13 VICTORIA PARADE
3 STOREY BRICK
MIXED USE BUILDING

PROPOSED S4.55(8) MODIFICATIONS LIST:

DRAWING TITLE	SCALE	STATUS	NUMBER	REVISION
SECOND FLOOR PLAN	1 : 100	s4.55 (8)	A1.04	A

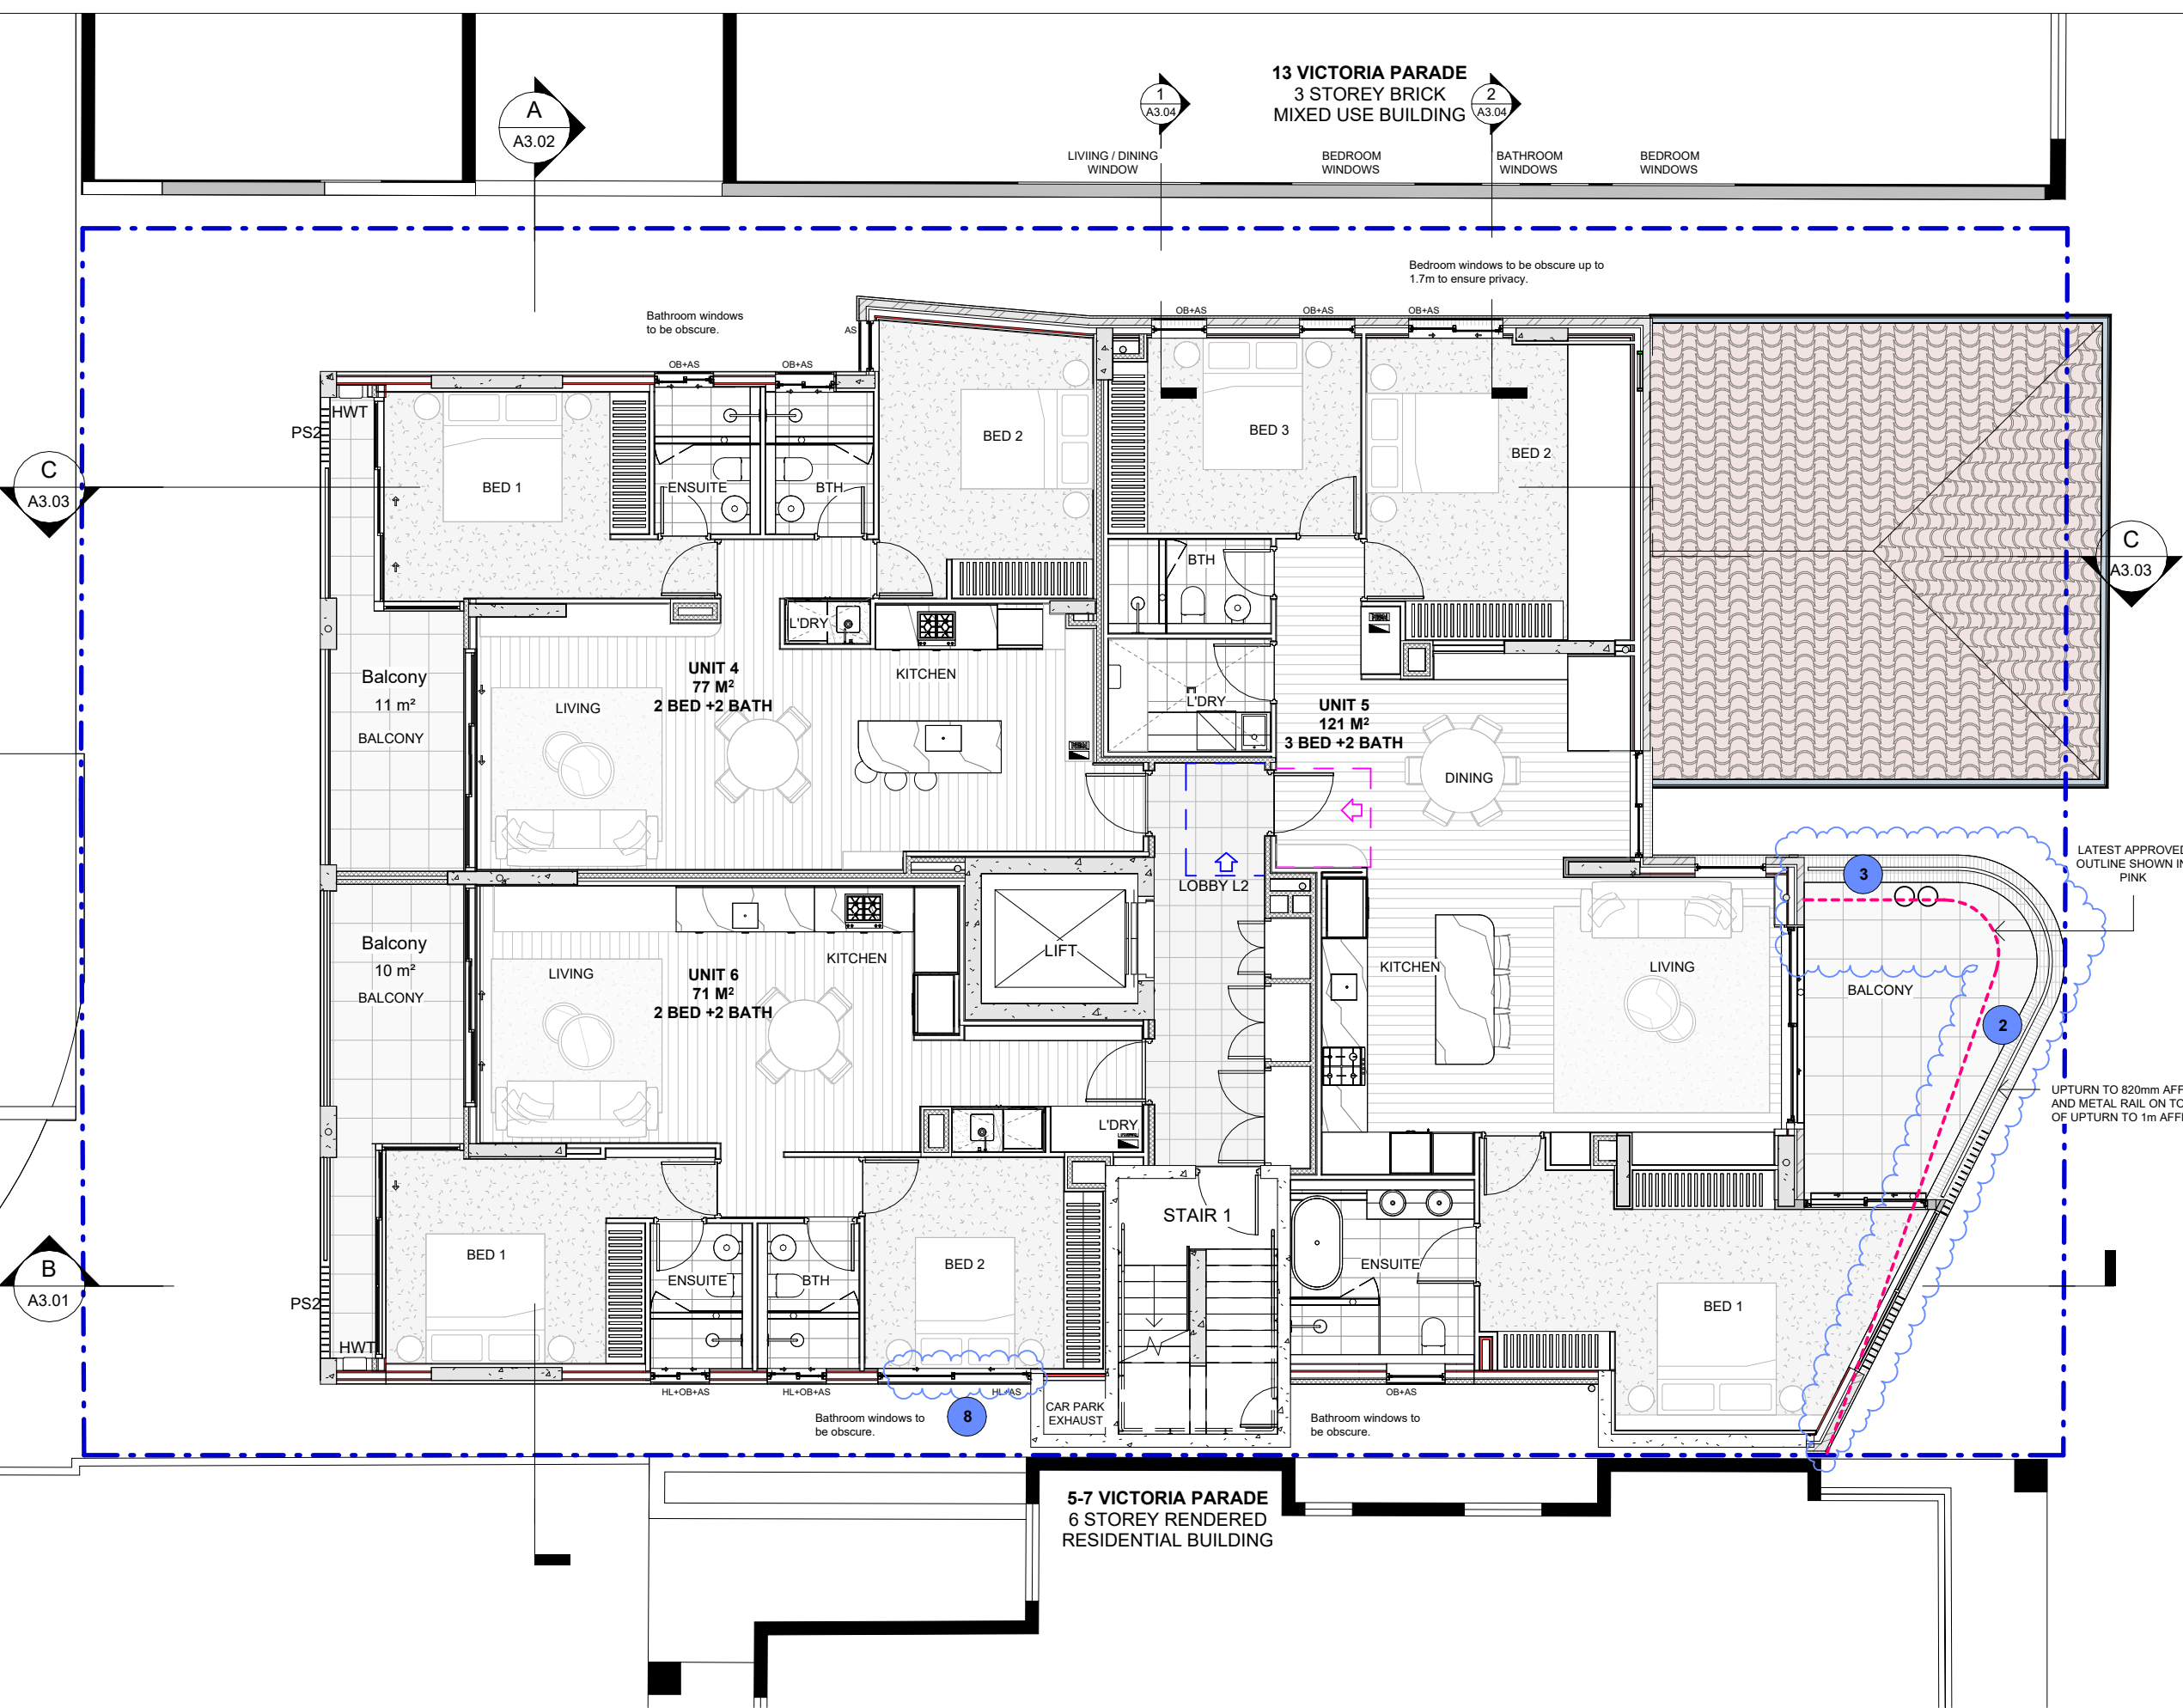
- Retail 1 on Ground floor has been pushed out to enhance the usable area and to suit new columns for balconies above.
- The front facade's angle has been adjusted to enlarge the front balconies and comply with ADG regulations of balcony size.

- Front balconies on level 1 and level 2 were extended to the north east to align with the approved balconies above to avoid looking 'top-heavy' and unbalanced.

- Level 4 brick wall shifted to align with adjacent brick walls.
- Cladding colour proposed to be off-white to visually lighten the bulk of the upper floors.

- Allocation of 1 bicycle space per unit in large storage cages in lieu of separate bicycle parking to satisfy the intention of condition 43D.
- Private roof terrace introduced to improve amenity of unit 14. The glass stair enclosure is not readily visible from the street and has no real impact on privacy, bulk or overshadowing.

- Increase in width of high-light windows to improve ventilation and natural lighting in the bedrooms with no privacy impacts.
- Minor adjustment to the GFA due to the above- still less than LEC approved FSR 3:1.

- Window heads have been lowered to 2.58m to fit services
